## CITY COUNCIL WORK SESSION MEMO

**MEETING DATE:** December 20, 2021  
**AGENDA ITEM:** Conceptual Review with Planning Commission -  
505 Oak Street Planned Development and Major Subdivision  
**FROM:** Kristi Jefferson, Planner

SITE PLAN - OPTION 1

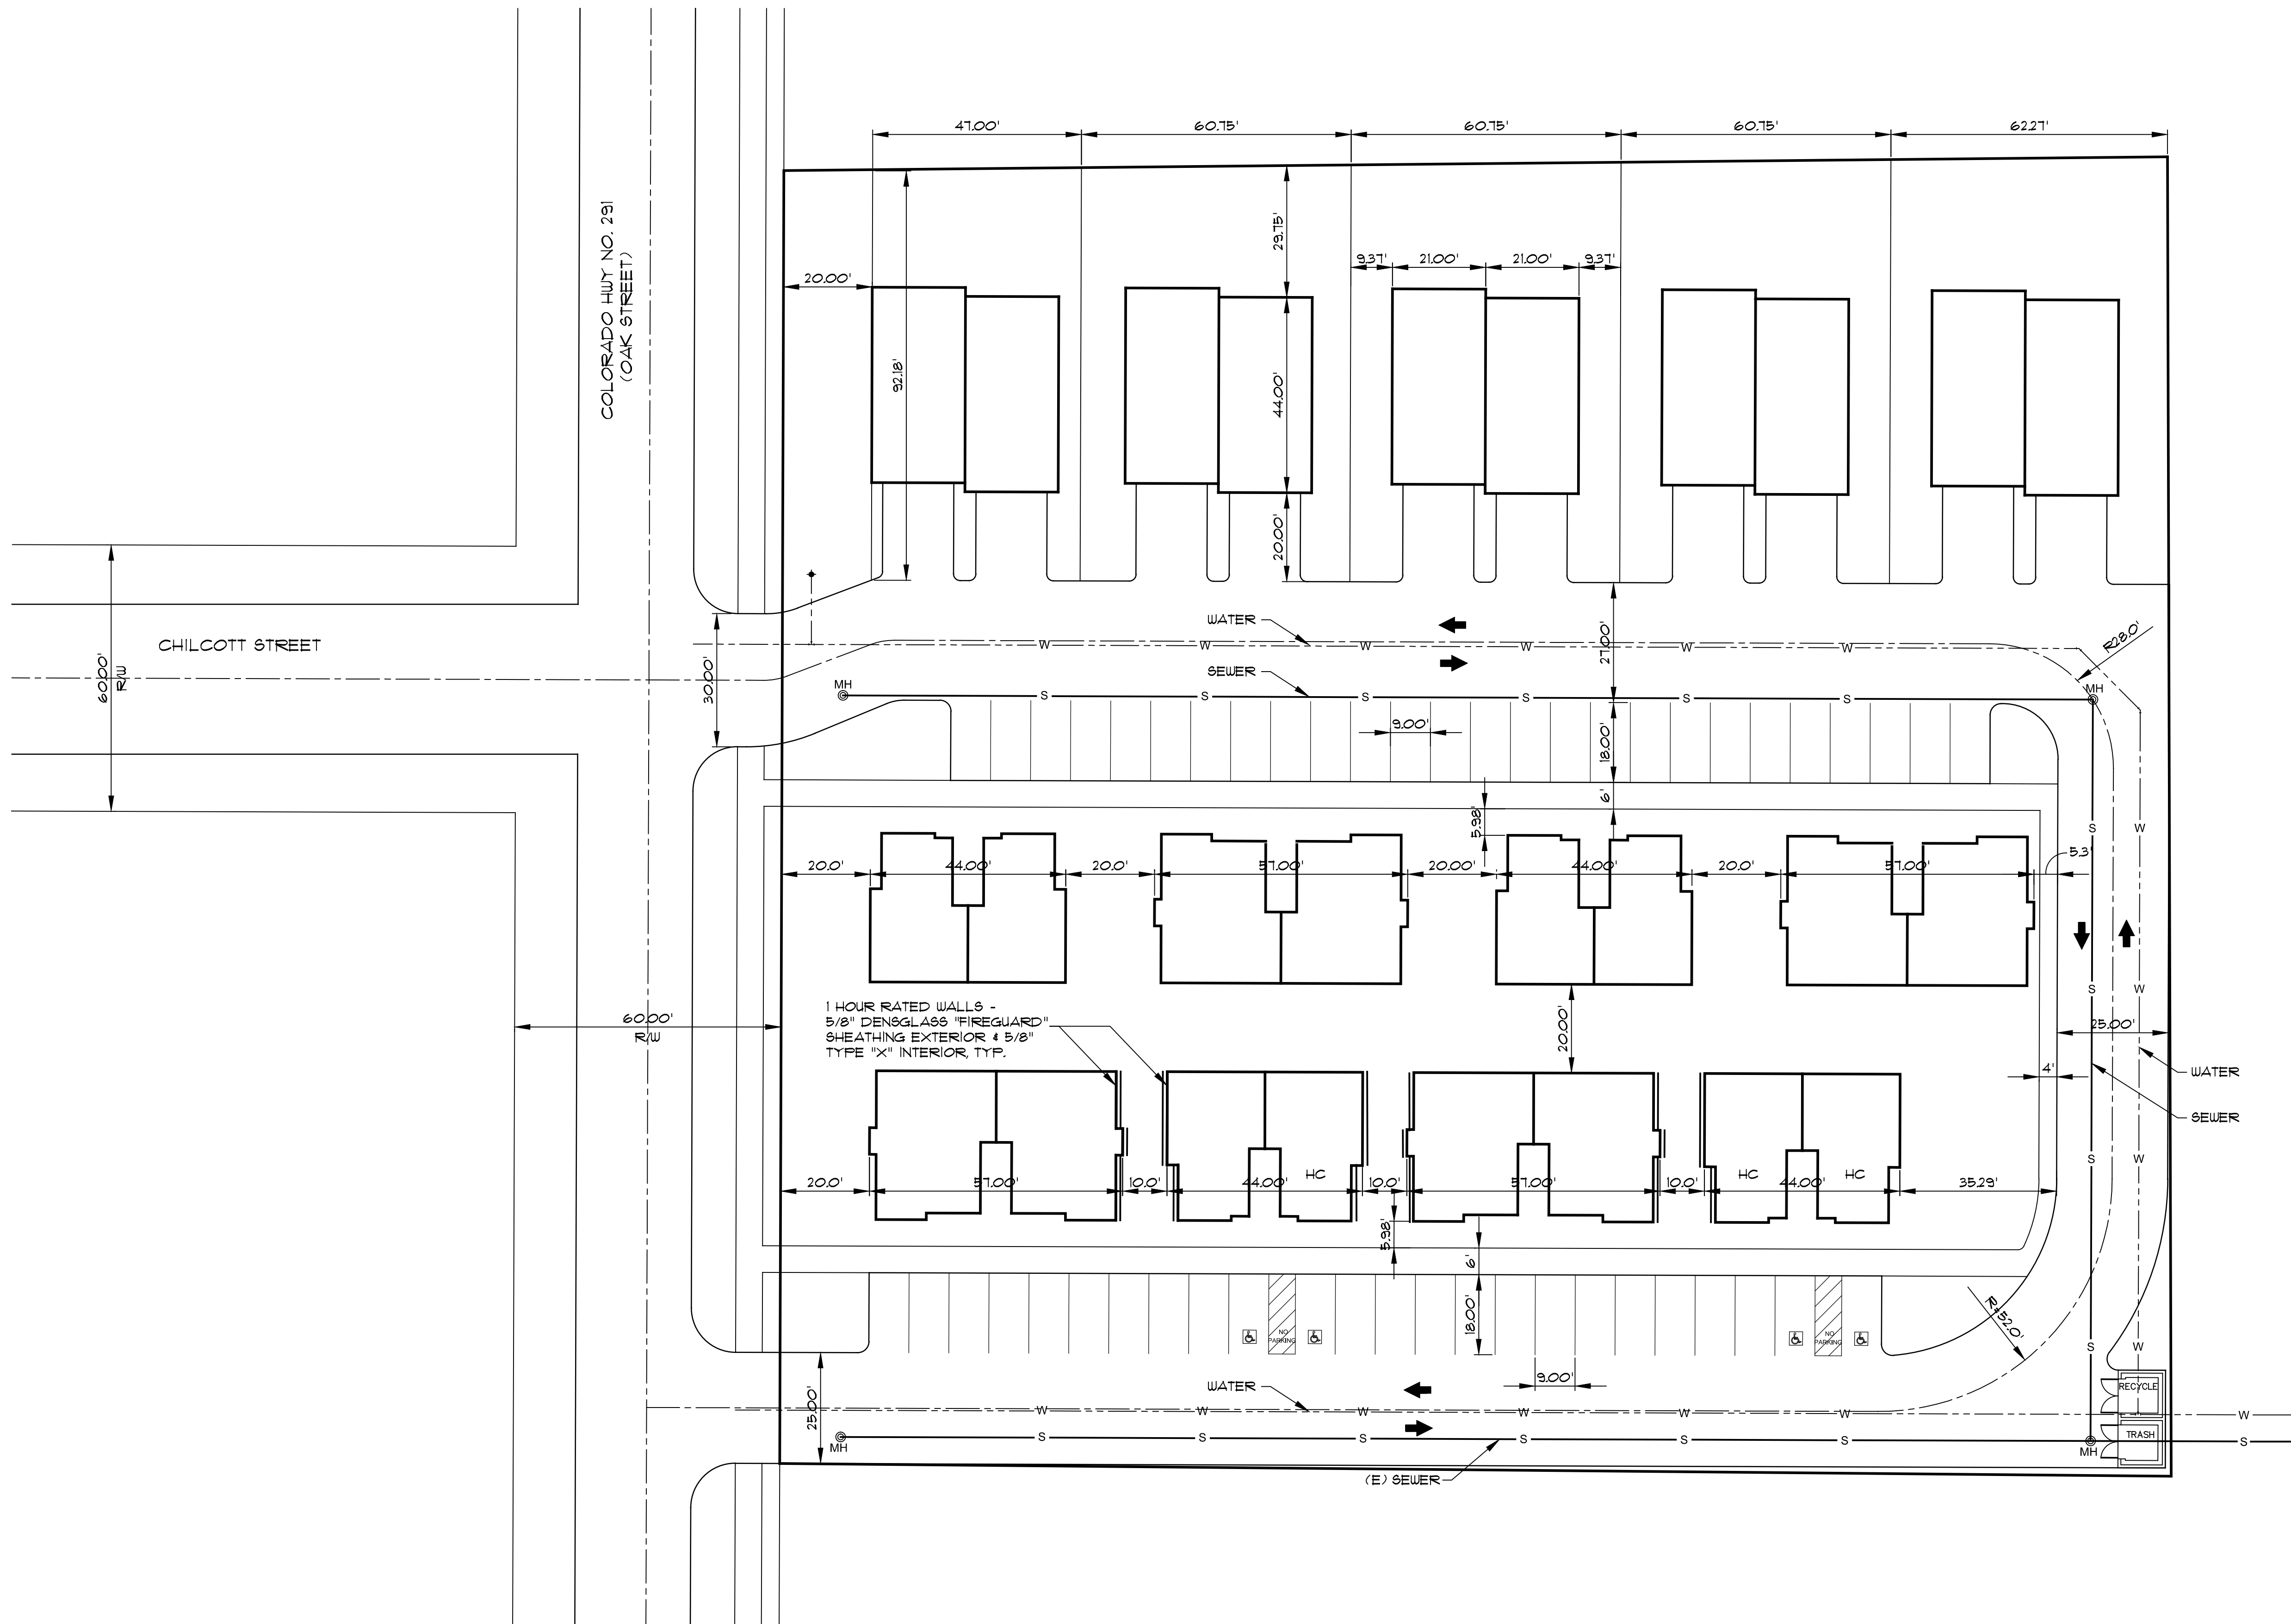
Two site plans were submitted for the conceptual review, one that shows all utilities located within the property and the second site plan shows a similar configuration of the units but the utilities are shown in a shared 25' utility easement with the adjoining property owner to the south (the City is under contract to purchase the adjoining parcel).

**Maximum density** - The maximum density allowed in the C-1 zone district for this 2.11 acre parcel is 32 units and the applicant is requesting for up to 42 units of density. The density allowance is increased to 37 units if the Inclusionary Housing is provided within the development - making the request approximately a 14% increase in density. The applicant has stated that they intend on deed restricting 4 of the apartment units to meet the inclusionary housing requirement of 12.5%. The inclusionary housing requirement is 5+ deed restricted units for the requested 42 units.

**Minimum lot frontage** – The proposed lots include frontage on a private road and not on a public street as required. The site plans show the alignment of Chilcott Street which will not be an extension of the public street but a private road within the development.
